Return To Library > Records 2 > ERID-105000 Through ERID-105499 > ERID-105038 1) SUBMITTAL OF THE RESPONSE TO THE NOTICE OF DISAPPROVAL FOR THE INVESTIGATION WORK PLAN FOR UPPER CANADA DEL BUEY AGGREGATE AREA AND REVISION 1, 2) NOTICE OF DISAPPROVAL EPA ID NO NM0890010515, HWB-LANL-08-013, LA-UR-08-6121, EP2008-0507, 3) INVESTIGATION WORK PLAN FOR UPPER CANADA DEL BUEY AGGREGATE AREA, REVISION 1, LA-UR-08-6122, EP2008-0508, 4) MAP PLATE 1, 5) ATTACHED CD LA-UR-08-6122, EP2008-0508

Date: September 29, 2008
Refer To: EP2008-0507

Subject: Submittal of the Response to the Notice of Disapproval for the Investigation Work Plan for Upper Cañada del Buey Aggregate Area and Revision 1

Figure 5.5-1 Site features for SWMUs 46-003(d), 46-004(a), 46-004(b), 46-004(c), 46-004(x), 46-004(y), 46-004(z), 46-006(d), 46-006(g), and AOC 46-004(f2)

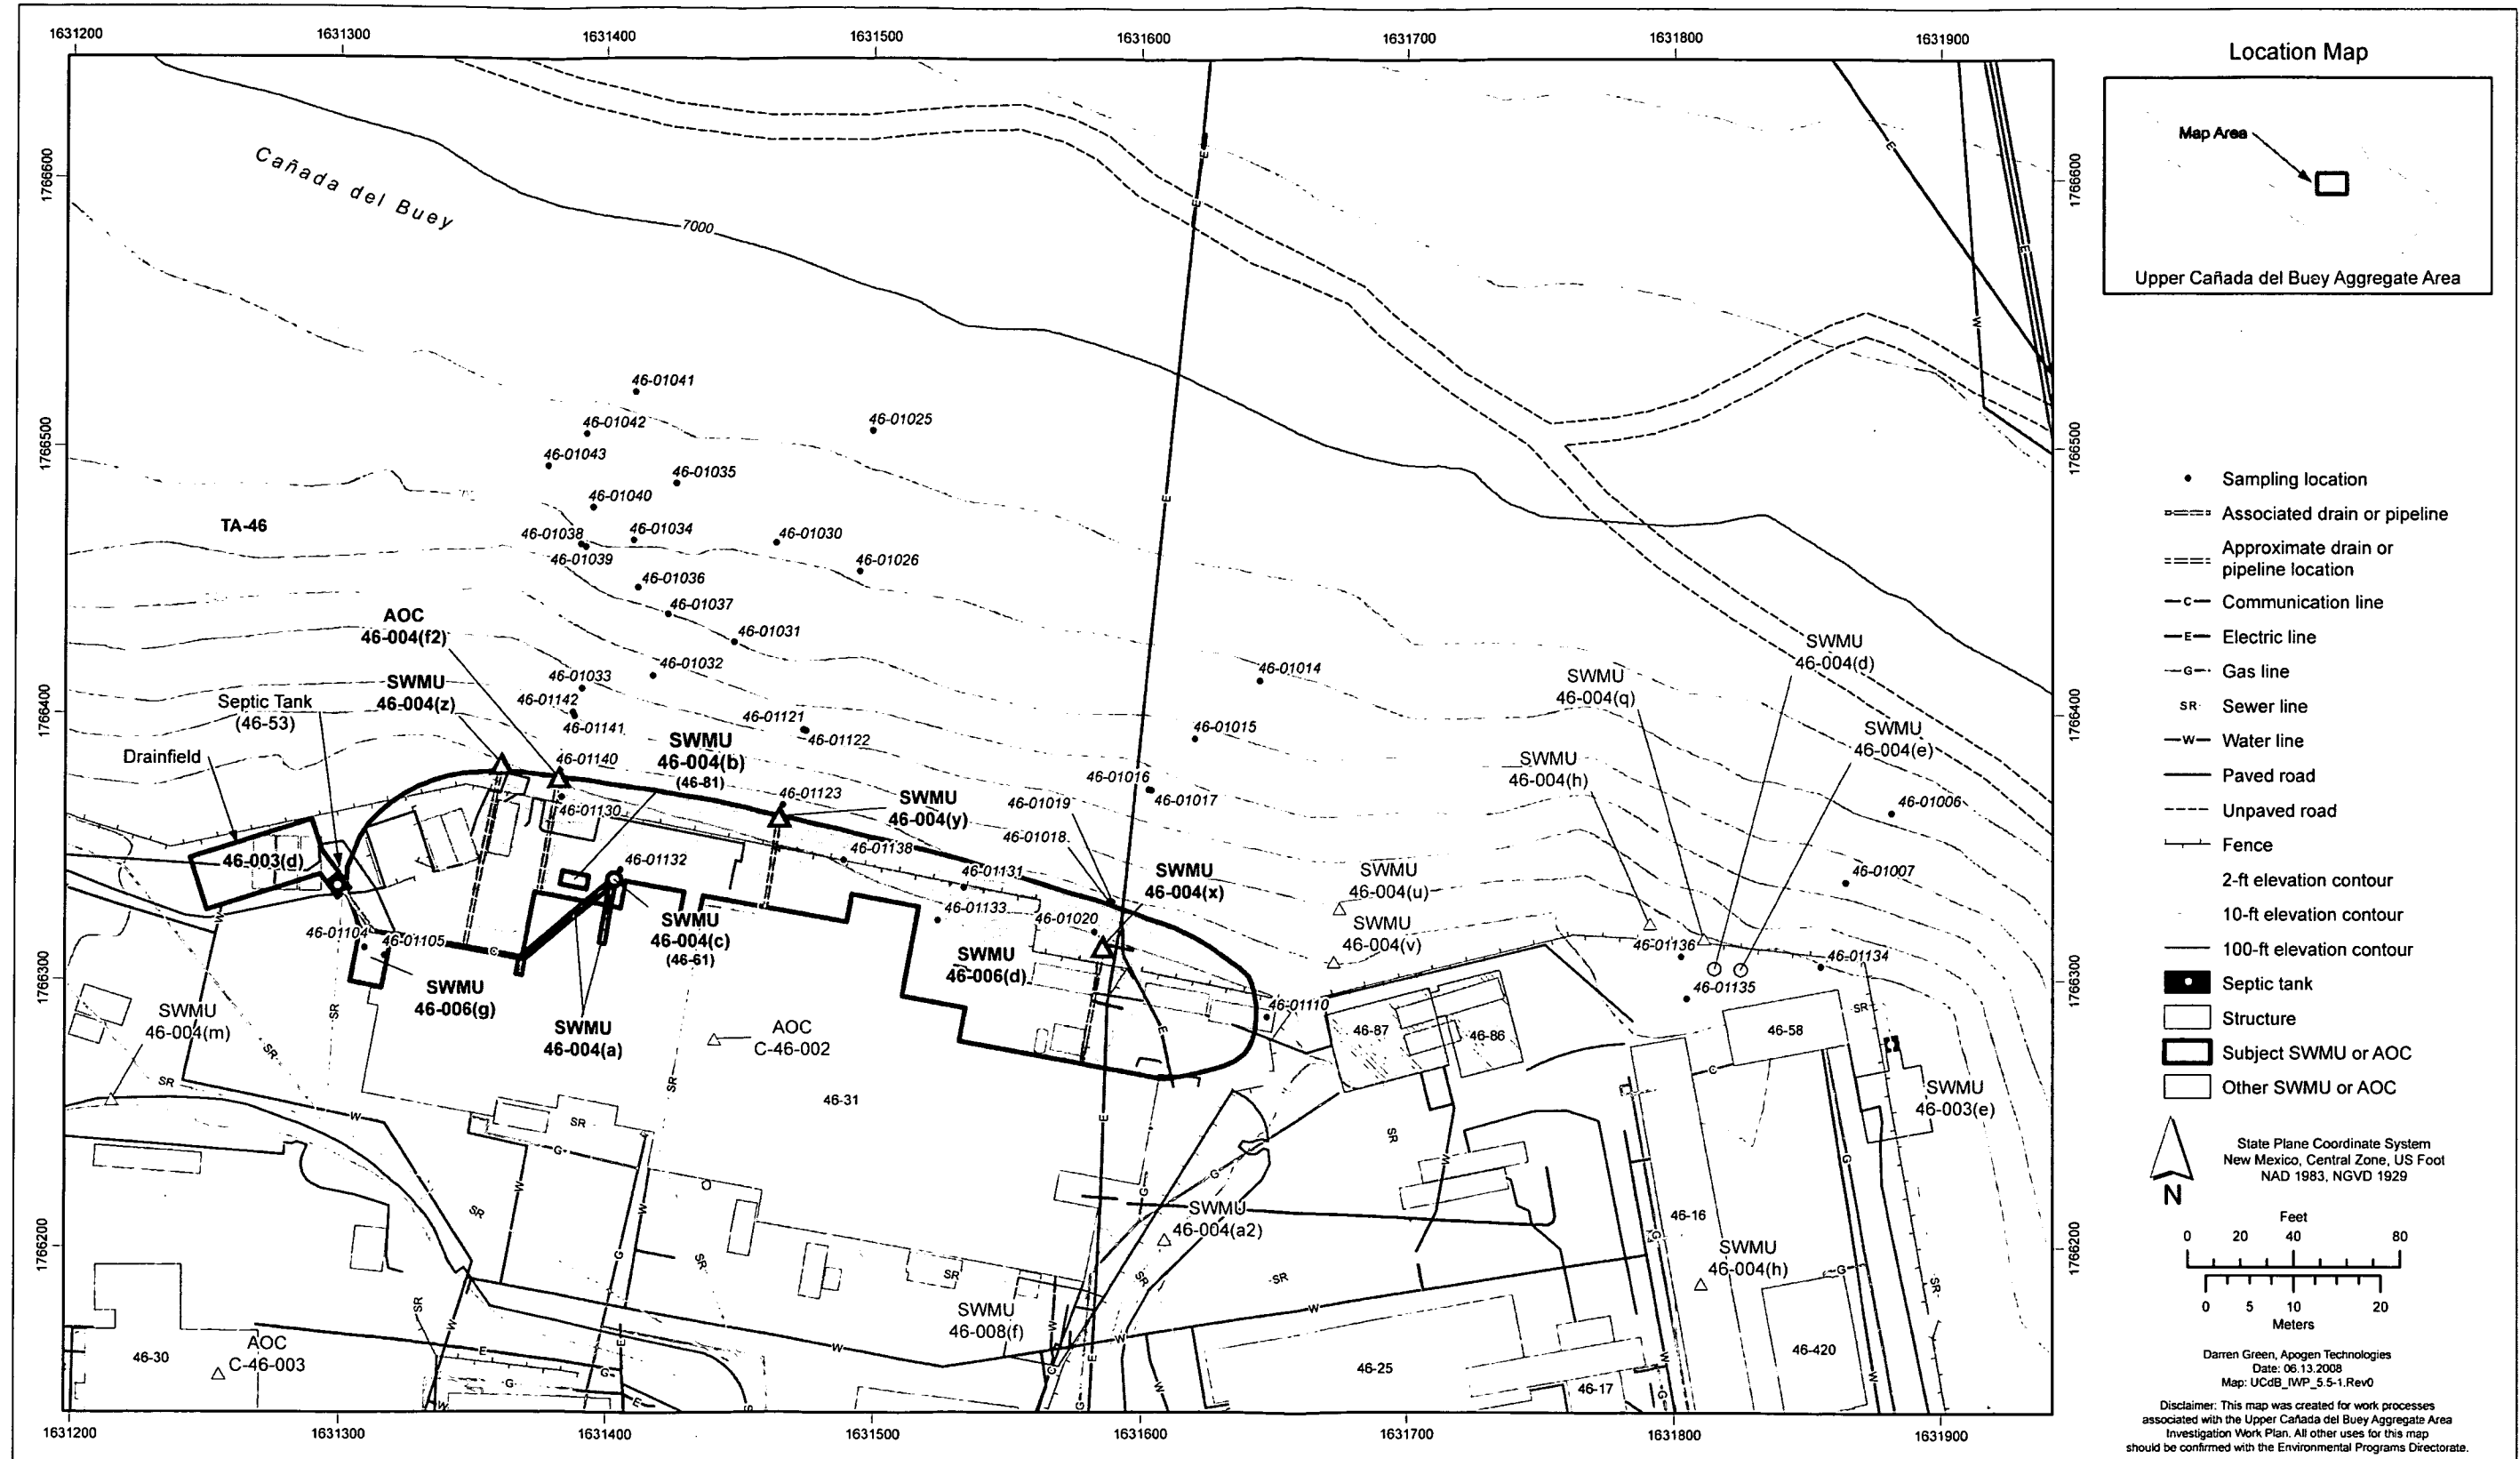
Permittees' Statement: "SWMU 46-004(b) is the location of a former alkali-metal cleaning tank (structure 46-81) (Figure 5.5-1)."

NMED Comment: Section 5.2.2 of the June 1996 RFI Report for Potential Release Sites in TA-46 (1996 RFI) indicates the former tank historically occupied at least two locations at SWMU 46-004(b). Review of Figure 5.2.2-1 of the 1996 RFI indicates neither of the historical tank locations shown on that figure correspond with the location shown on Figure 5.5-1 of the Plan. The Permittees must explain why the tank location shown in the Plan figure differs from the locations shown on the 1996 RFI figure.

5. Figure 5.5-1 of the work plan shows the original (operating) location of the SWMU 46-004(b) alkali-metal cleaning tank but does not show the second (staging) location. The location of the tank as shown in Figure 5.5-1 is based on the location shown in engineering drawing C-38763 (Attachment 1). The tank location depicted in the 1996 Resource Conservation and Recovery Act

As shown in the 1996 RFI report figure, the tank occupied a second location for a short period of time (LANL 1996, 054929). In 1970–1971, during the construction of the Arc Jet Test addition at building 46-31, the tank was emptied, disconnected from piping, and moved to an existing concrete pad located approximately 15 ft northwest of the original tank location. Engineering drawing C-38763 (dated September 14, 1970) directs that the piping to the tank be capped and provides no direction for installing piping at the tank's new location, indicating that the tank would no longer be used. As is common practice in many technical areas throughout the Laboratory, equipment removed from service is often placed at a convenient outside location until the items can be removed for disposal. The tank was staged at this location until it was removed for disposal in 1973.

The second location of the tank was used only for staging the tank before it was removed off-site. The tank did not operate during the time it occupied this location. Therefore, LANL did not indicate the second location of the tank on Figure 5.5-1, and sampling at this location is not necessary.

Figure 5.6-1 Site features for SWMUs 46-003(e), 46-004(a2), 46-004(d), 46-004(e), 46-004(h) (outfall), 46-004(q), 46-004(u), 46-004(v), and 46-008(f)

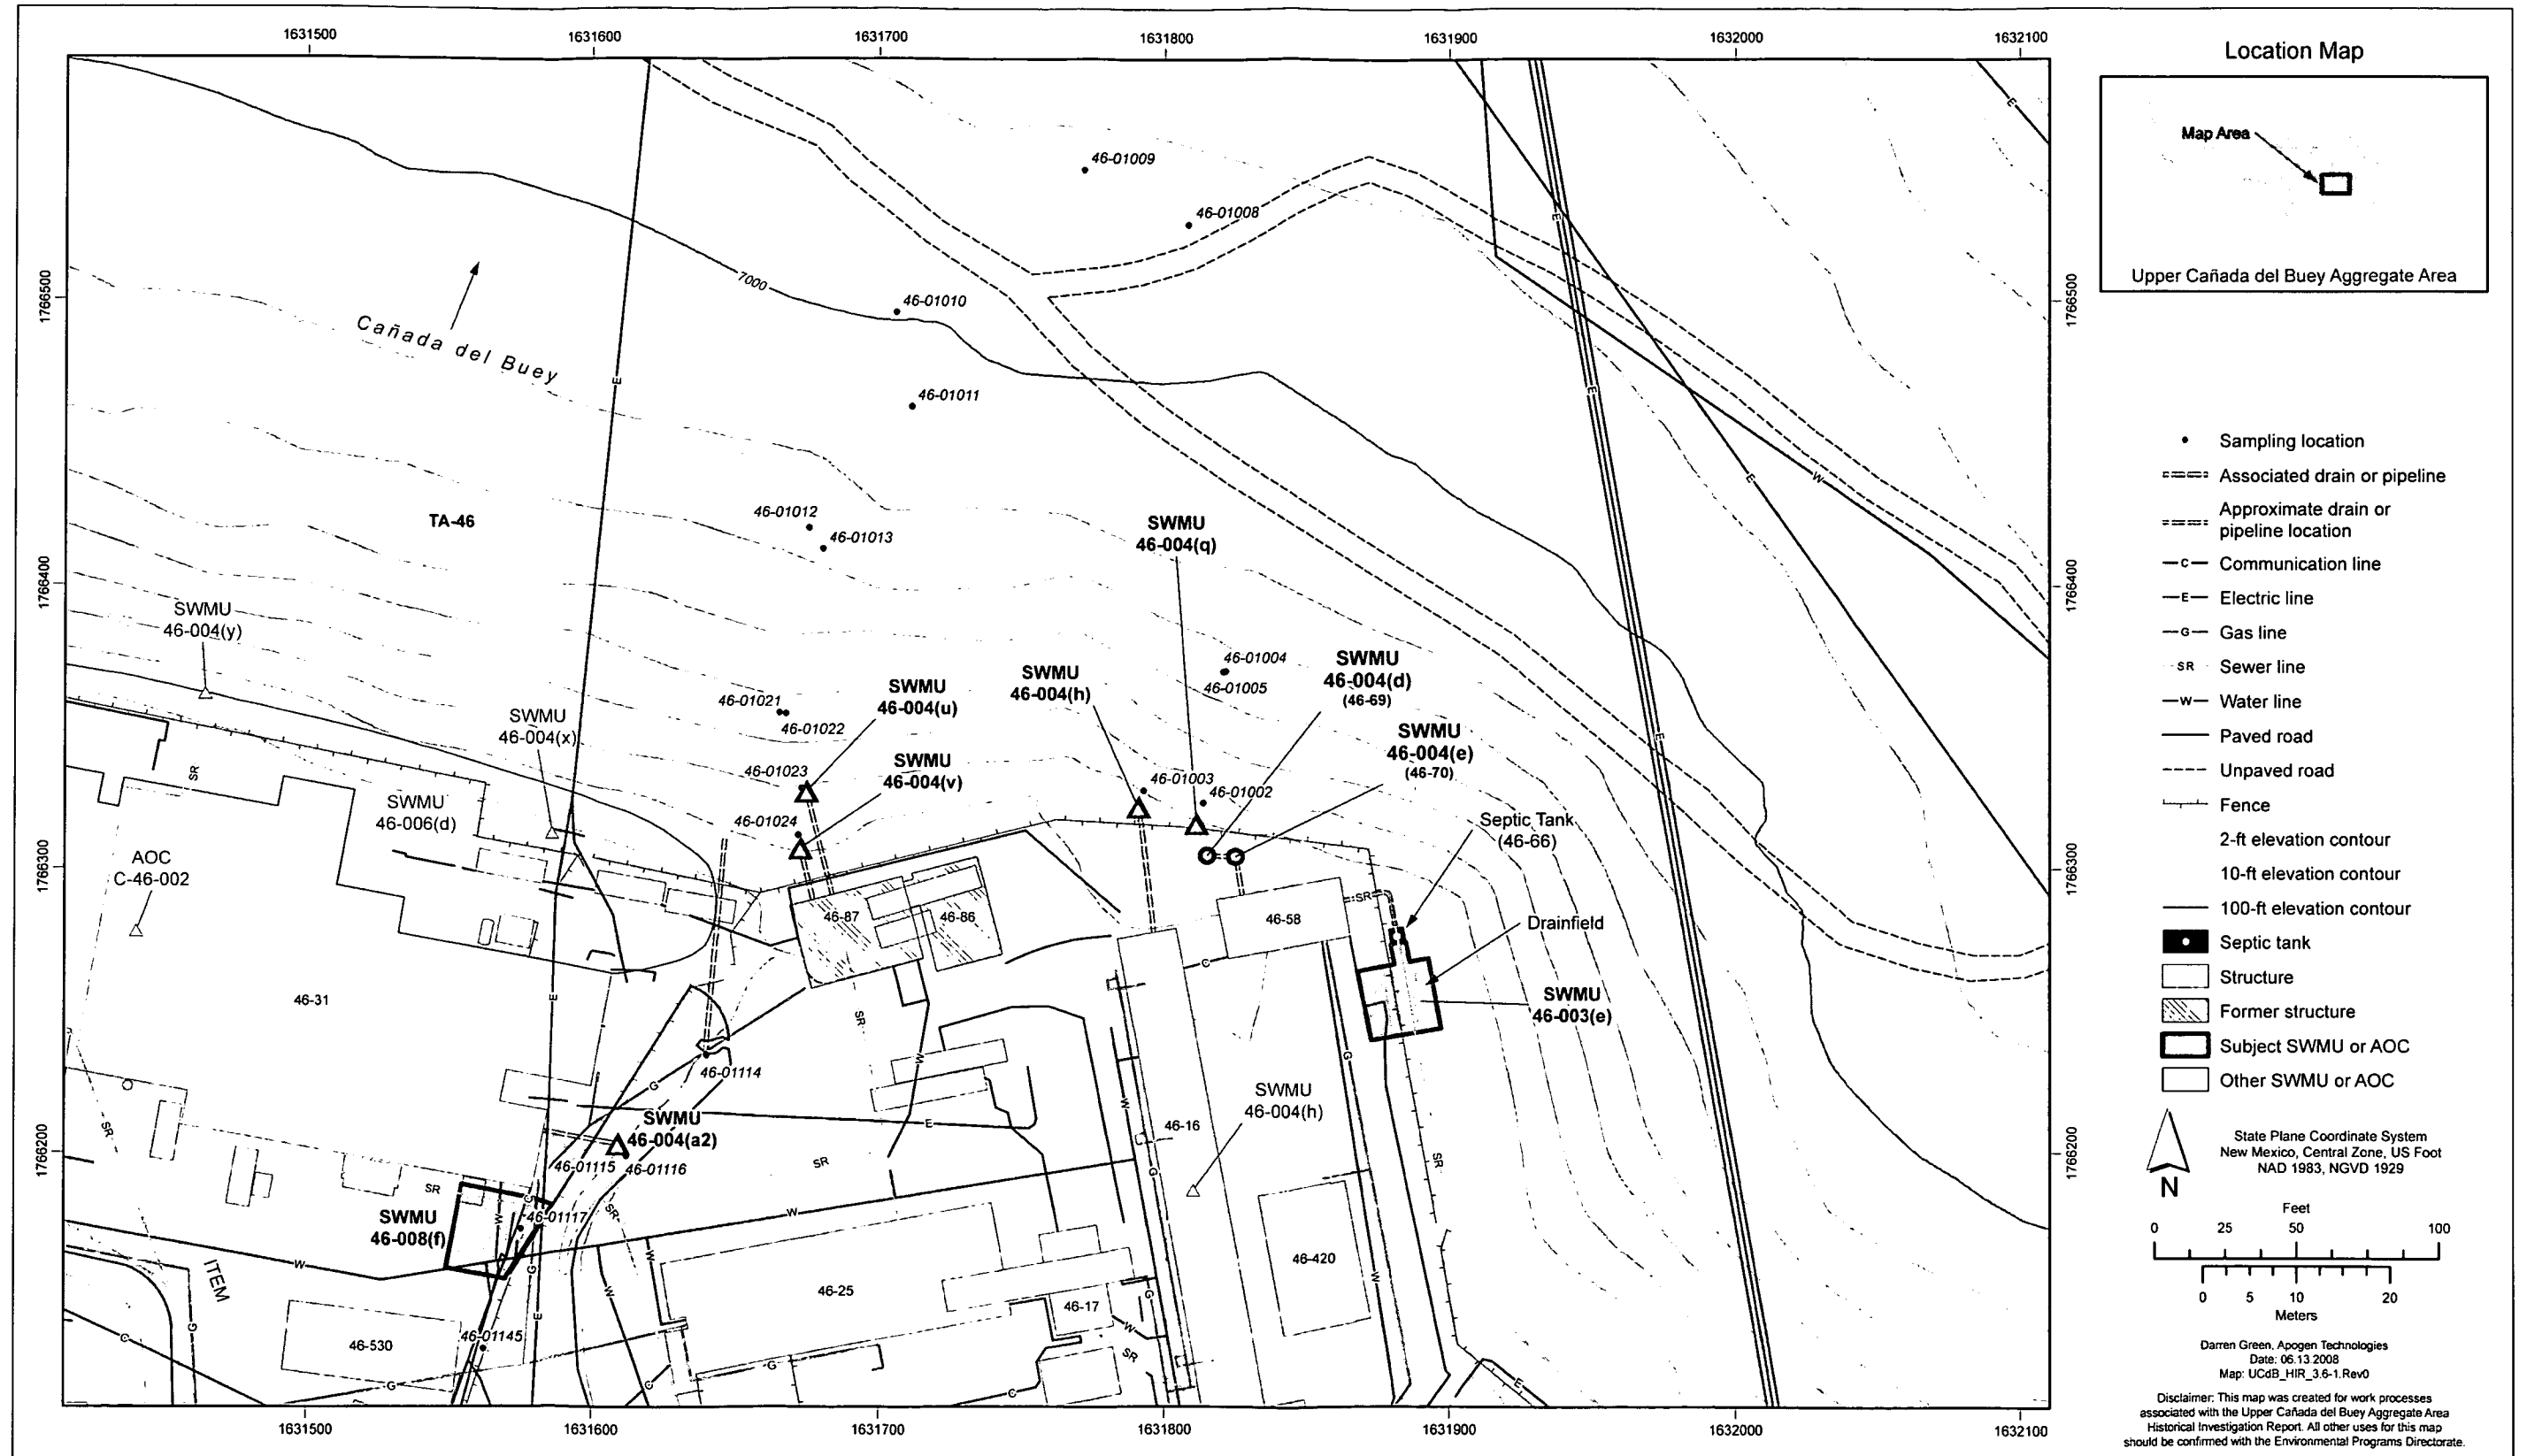
Permittees' Statement: "SWMU 46-004(q) is an outfall located north of building 46-58 (Figure 5.6-1)."

NMED Comment: Figure 5.21.11-3 of the 1996 RFI shows three outfalls (designated A, B and C) associated with SWMU 46-004(q). As illustrated on that figure, the three outfalls are shown as being approximately 25 feet from each other. The 1996 RFI and the associated RFI Work Plan indicate only one of the three outfalls (Outfall "B") was sampled during the RFI field effort. The figure indicates Outfall "C" was located at the end of a drain line which is shown as originating near the northwest corner of building 46-16. The 1996 RFI narrative indicates Outfall C was a two foot diameter culvert that received parking lot runoff from the northeast quadrant of TA-46. The RFI Work Plan and the 1996 RFI narratives indicate the source of Outfall B was unknown. Neither document discussed the nature and origin(s) of Outfall "A".

During field investigations in preparation for writing the 1993 RFI work plan for Operable Unit (OU) 1140, alphanumeric field designators were given to outfalls at Technical Area 46 (TA-46) (LANL 1993, 020952). The field designators were merely used as a method for easily locating the outfalls during field investigations and were not linked to SWMU or area of concern (AOC) designations. Figure 5.21.11-3 of the 1996 RFI report shows three of these outfalls (designated A, B, and C), which are located within close proximity of each other (LANL 1996, 054929). Although the figure shows Outfalls A, B, and C within the boundary of SWMU 46-004(q), the figure is incorrect. Outfalls B and C are in close proximity to, but do not fall within, the SWMU 46-004(q) boundary. Text in the 1993 RFI work plan (p. 5-124) corroborates that Outfall A is SWMU 46-004(h) and goes on to describe the source of Outfall A as the floor drains and possibly the roof drains in building 46-16. The 1993 RFI work plan also provides the description for SWMU 46-004(q), stating that the SWMU is Outfall B
